MIL-C-172C
AMENDMENT 6
15 February 2001
SUPERSEDING
AMENDMENT 2
20 October 1966

MILITARY SPECIFICATION

CASES; BASES, MOUNTING; AND MOUNTS VIBRATION (FOR USE WITH ELECTRONIC EQUIPMENT IN AIRCRAFT)

FIGURE 6. Automatic locking device.

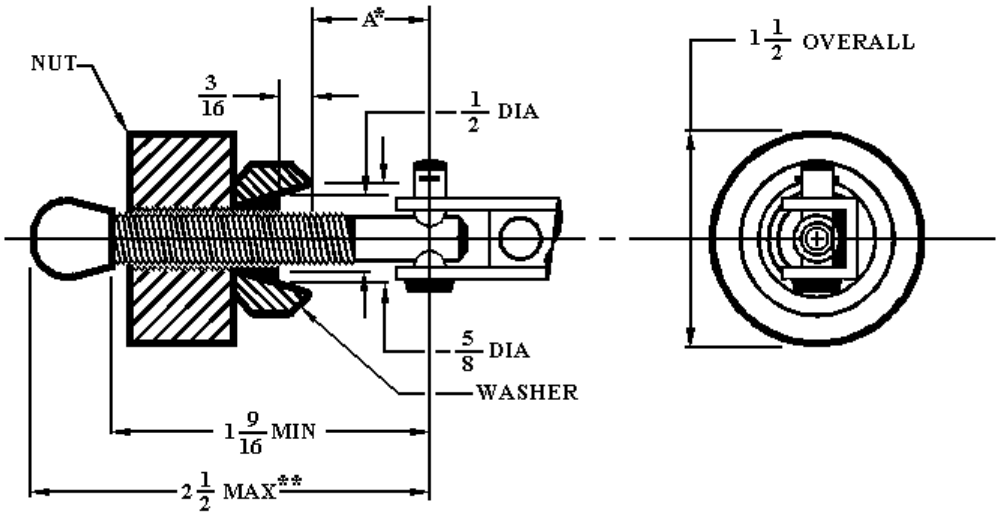
"3.5.2.1.2 Automatic locking devices. For all Air Force procurement only automatic locking devices shall be use in all cases, bases, and mounts to prevent loosening thereof under vibration. Dimensions shall be within the envelope shown in figure 6. For Army and Navy procurement automatic looking may be used provided they are specified by the procuring activity."

Insert figure 6:

* CLEARANCE ON OPEN OR EXTENDED POSITION 1-3/8 MINIMUM FOR DIMENSION A

** THIS DIMENSION SHALL BE NO GREATER THAN NECESSARY TO MEET THE MINIMUM CLEARANCE OF DIMENSION A

MATERIAL: CORROSION-RESISTANT STEEL
